Agilent Technologies 8514A/B, 8515A, 8517A/B, 85110A/L Test Set DC Return Upgrade Kits

Manufacturing Part Number: 08510-90504

Test Set DC Return Upgrade Kits

This installation note documents the recommended procedure for installing the Test Set D.C. Return Upgrade Kits, for Use With HP 8510C Firmware Rev C.07.00 or greater. This procedure is to eliminate an HP 8360 series source over-modulation error.

Figure 1-1. HP 08510-60119 D.C. Return Upgrade Kit.

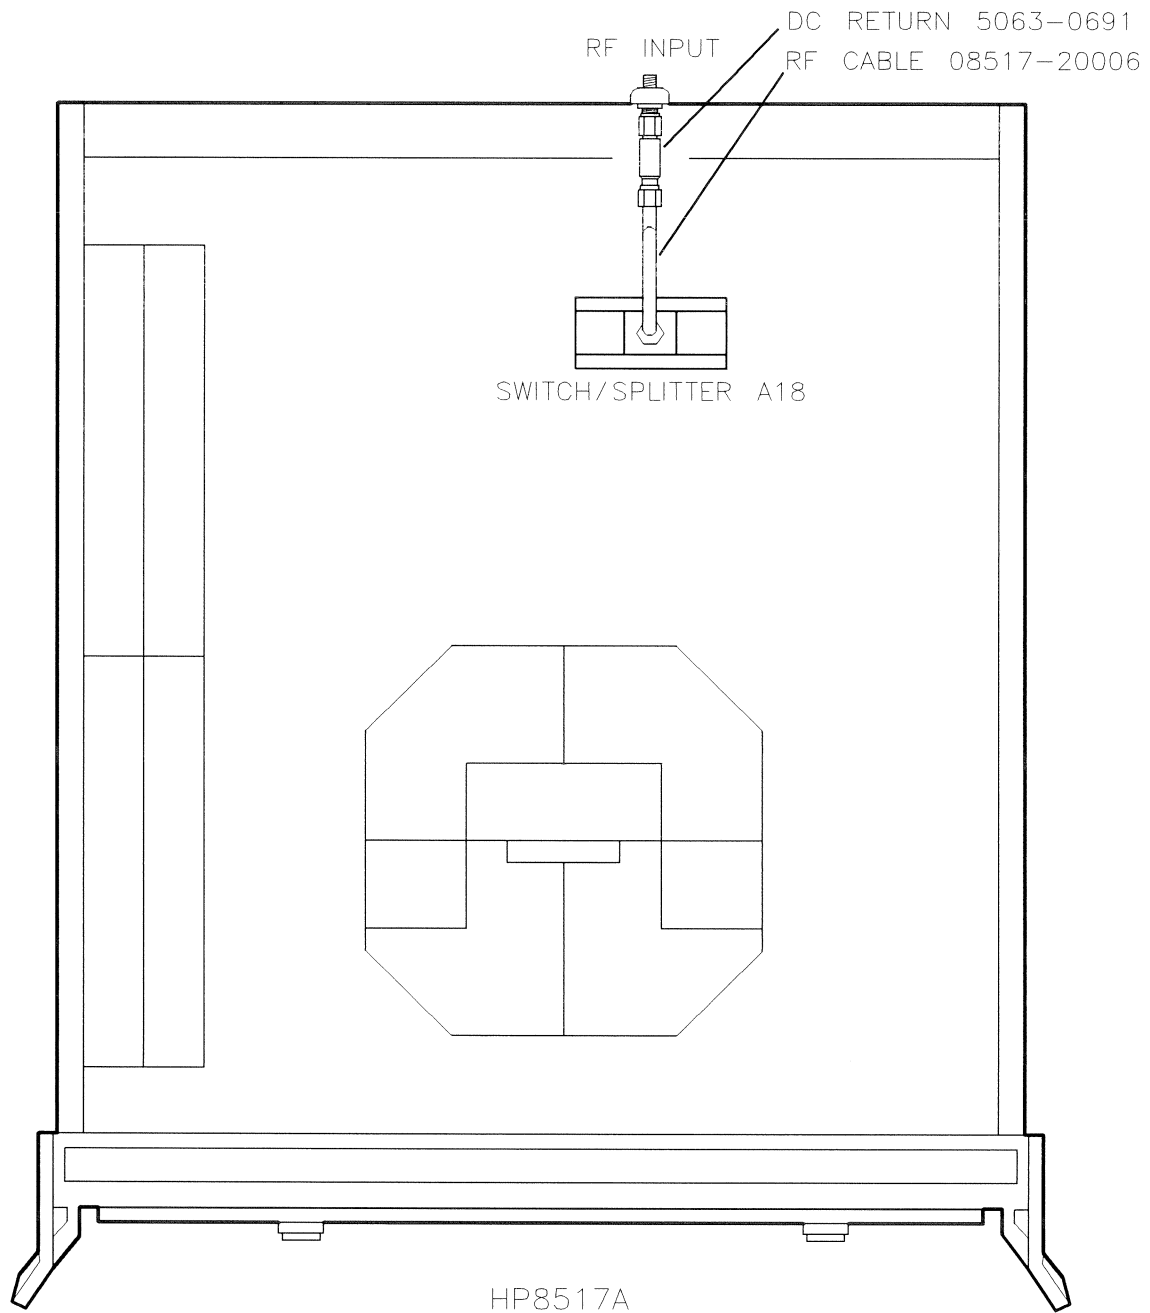
1. Remove old RF input cable going from RF input connector to switch/splitter, A18.
Replace with cable and D.C. return as shown.

Figure 1-2. HP 08510-60122 D.C. Return Upgrade Kit.

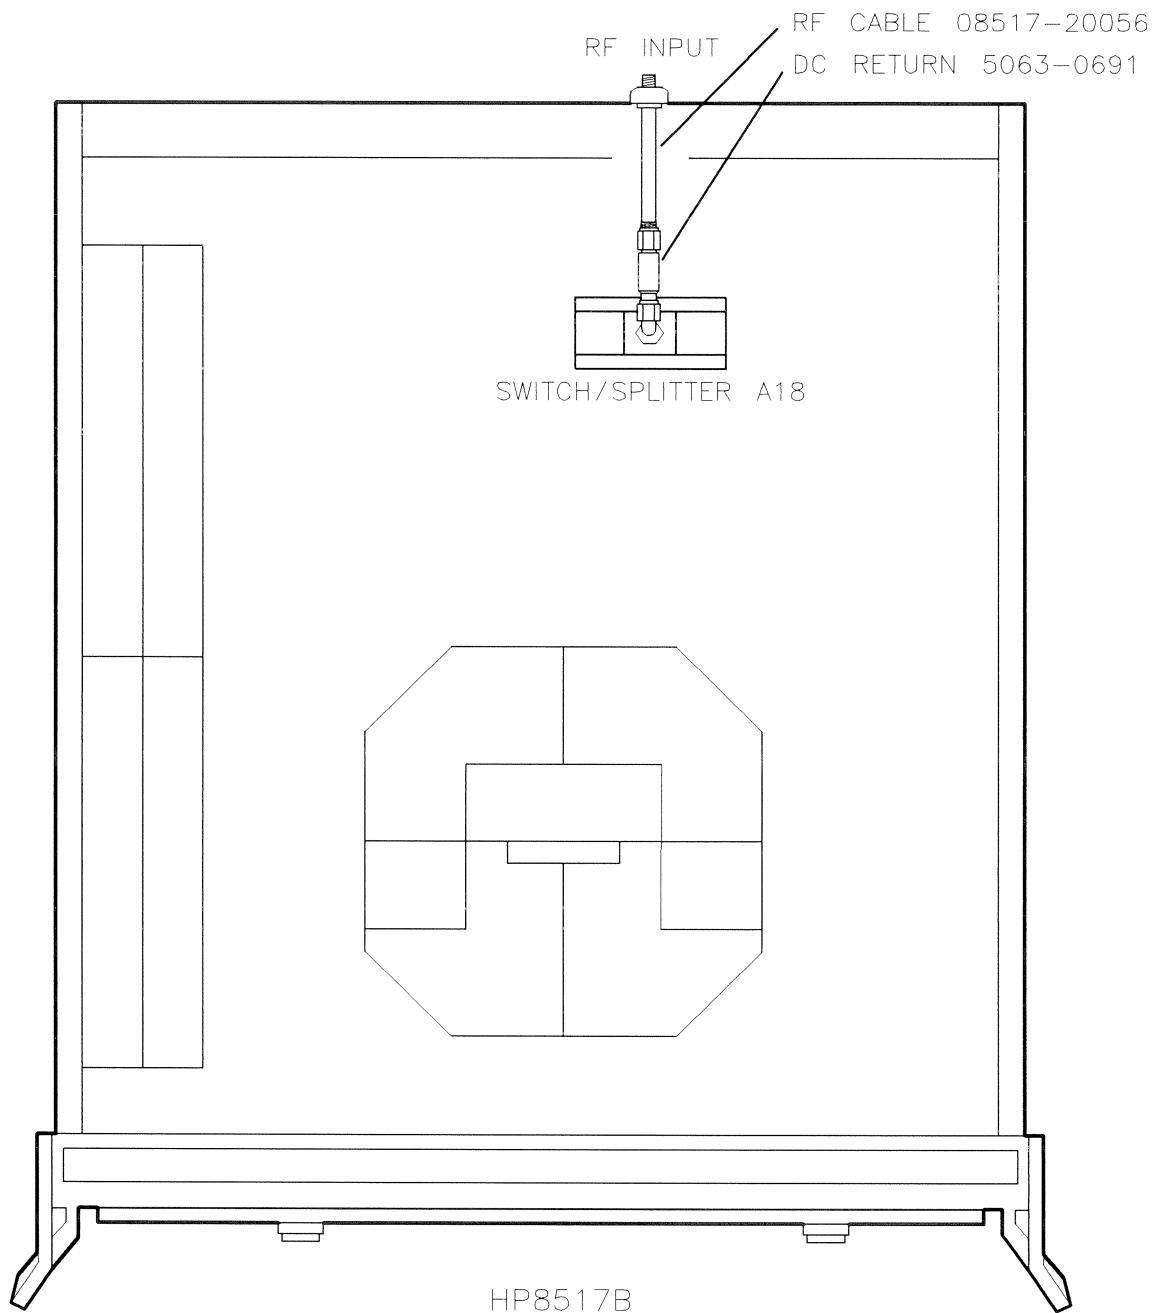
1. Remove old RF input cable going from RF input connector to switch/splitter, A18.
Replace with cable and D.C. return as shown.

Figure 1-3. HP 08510-60118 D.C. Return Upgrade Kit.

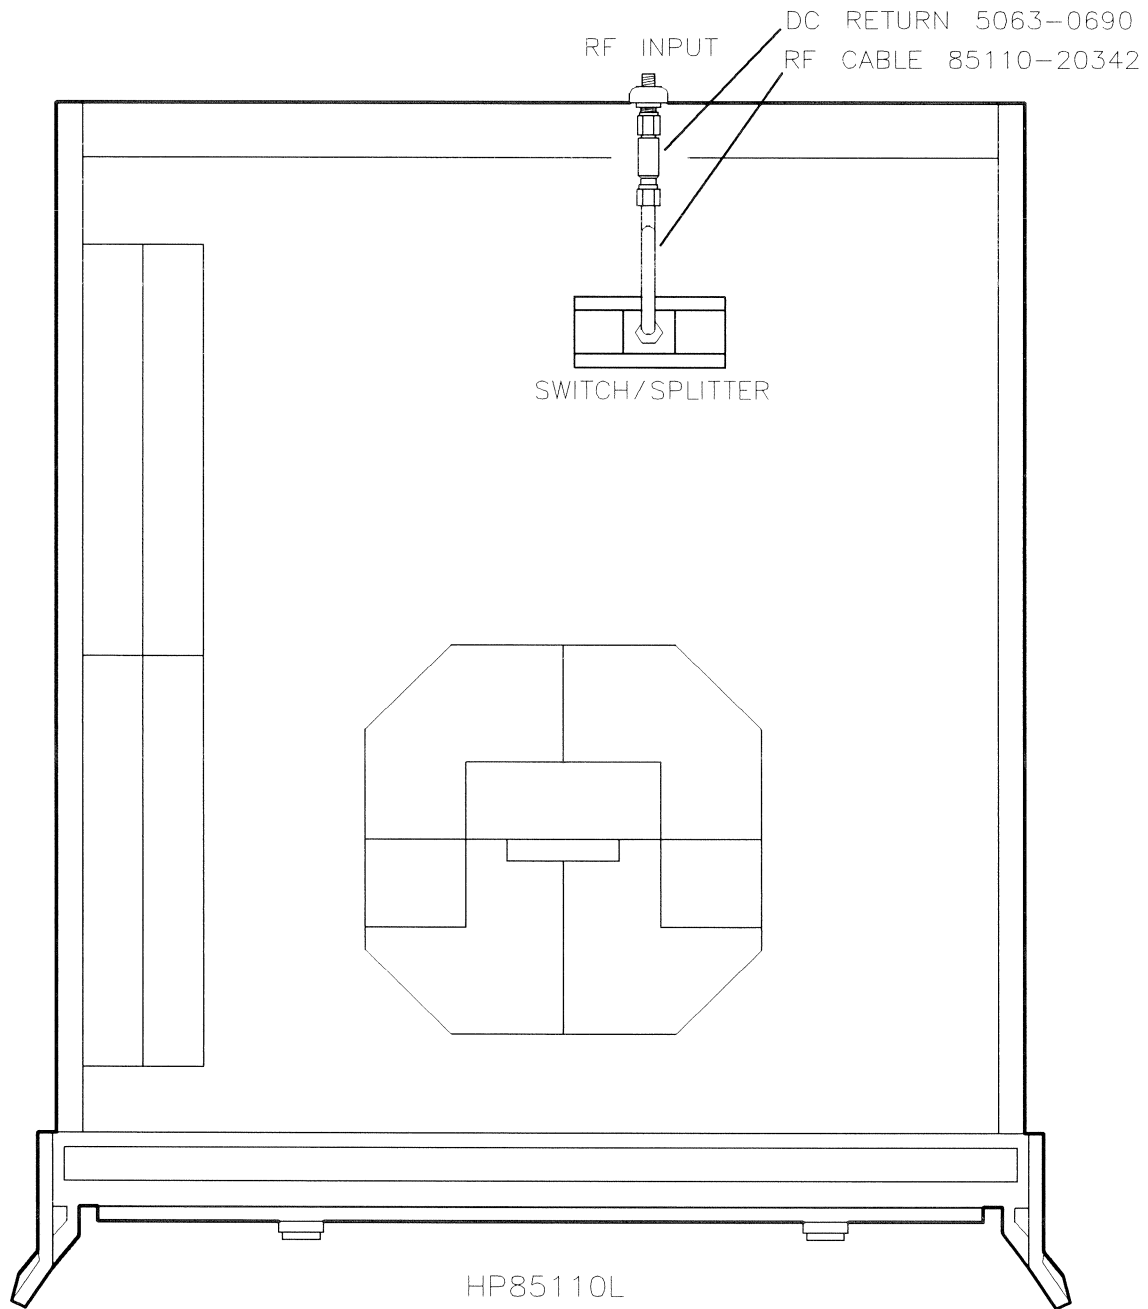
1. Remove old RF input cable going from RF input connector to switch/splitter, A18.
Replace with cable and D.C. return as shown.
